Dutcher Road Bridge #10471 over Northwest Drain

Superstructure Replacement

**Addendum 1**

**Addendum 1 adds the following changes:**

TUSCOLA COUNTY ROAD COMMISSION  
SPECIAL PROVISION FOR STRUCTURE NAME PLATE

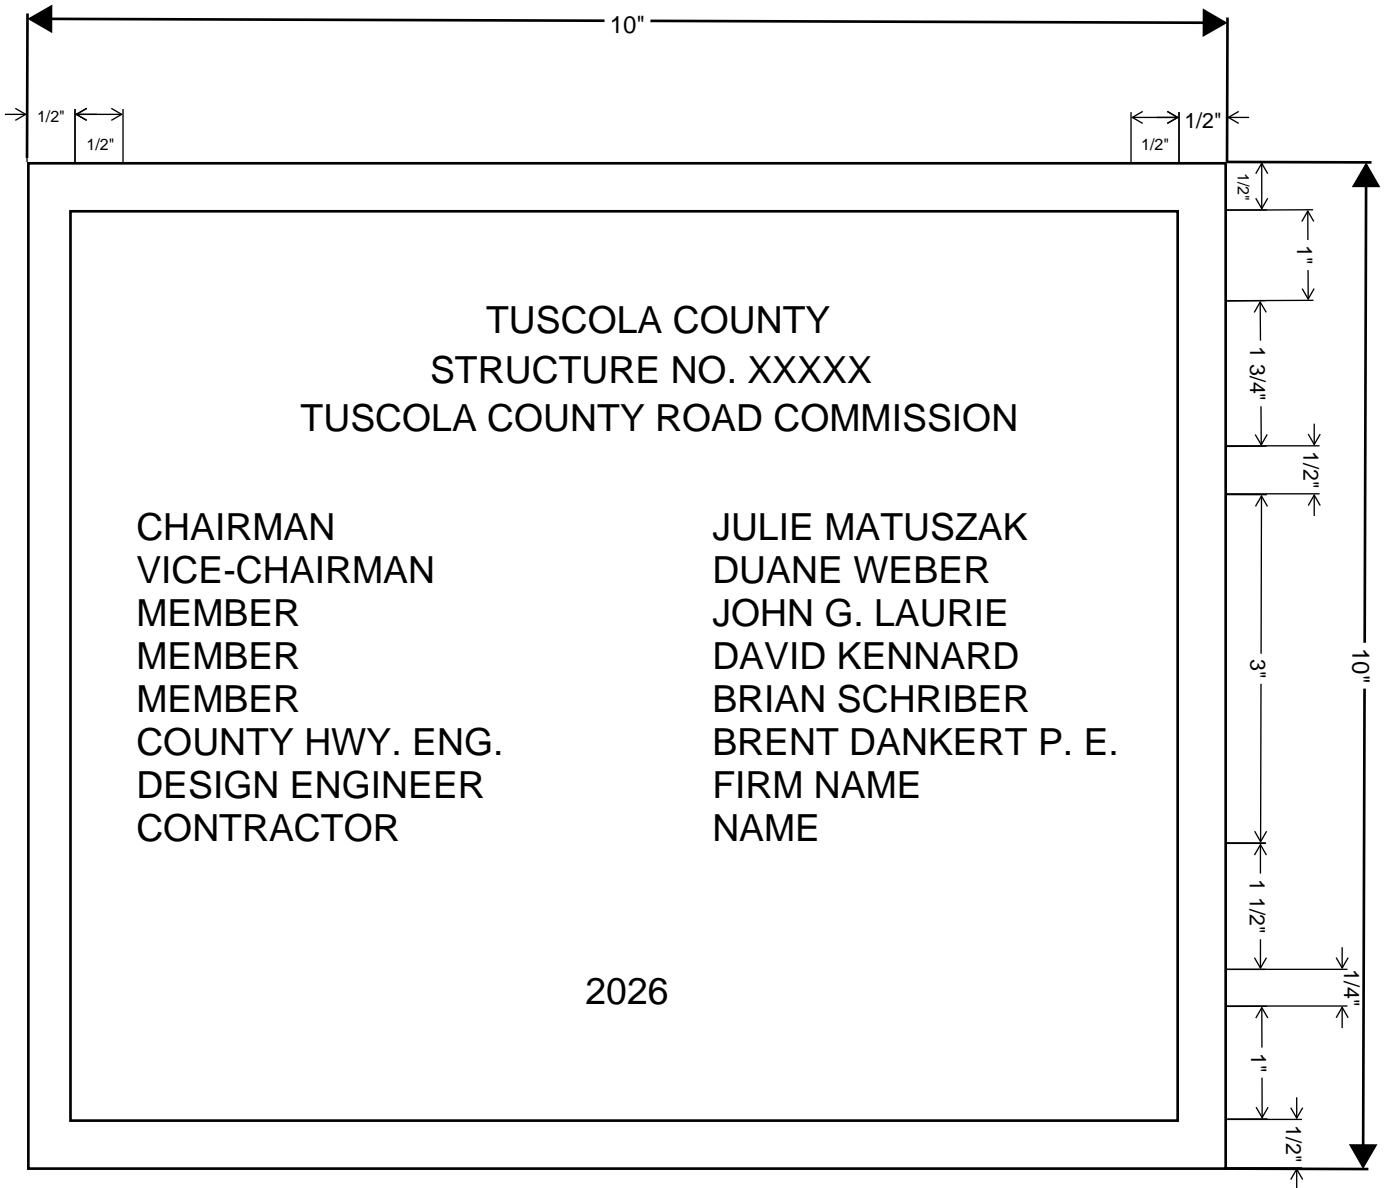
1. Adds Pay Item "Drainage Structure Cover Type XXX"
  - a. ***Dr Structure Cover, Type XX:*** Material and work shall be completed in accordance with Section 403 of the MDOT 2012 SSFC and as modified here. Pay item includes all transportation, hauling, delivery, materials, labor and equipment for a complete installation.
  - b. See Revised Plan Sheet 9
2. Adds Pay Item "Structure Name Plate"
  - a. See attached Special Provision.
3. See Revised Bid Tab to add the following two new items
  - a. Drainage Structure Cover Type K
  - b. Structure Name Plate
4. Revises RFP Page 1 and Page 7

All lettering shall be Gothic Condensed Deep Block Type of approximately the following proportions: (Height as shown on plans)

Depth	1/16 inch
Face Thickness	1/6 of height

**NOTES:**

BOARD MEMBERS NAMES AND YEAR OF CONSTRUCTION SUBJECT TO CHANGE.

PEBBLE BACKGROUND WITH POLISHED BORDER CONSTRUCTION SUBJECT TO CHANGE.

LETTER AND NUMBER SIZES ARE APPROXIMATE SLIGHT VARIATIONS FROM SIZE ARE ALLOWED.

PROVIDE (4) 3/8" DIAMETER L-SHAPED ANCHORS, MINIMUM 3" EMBEDMENT.
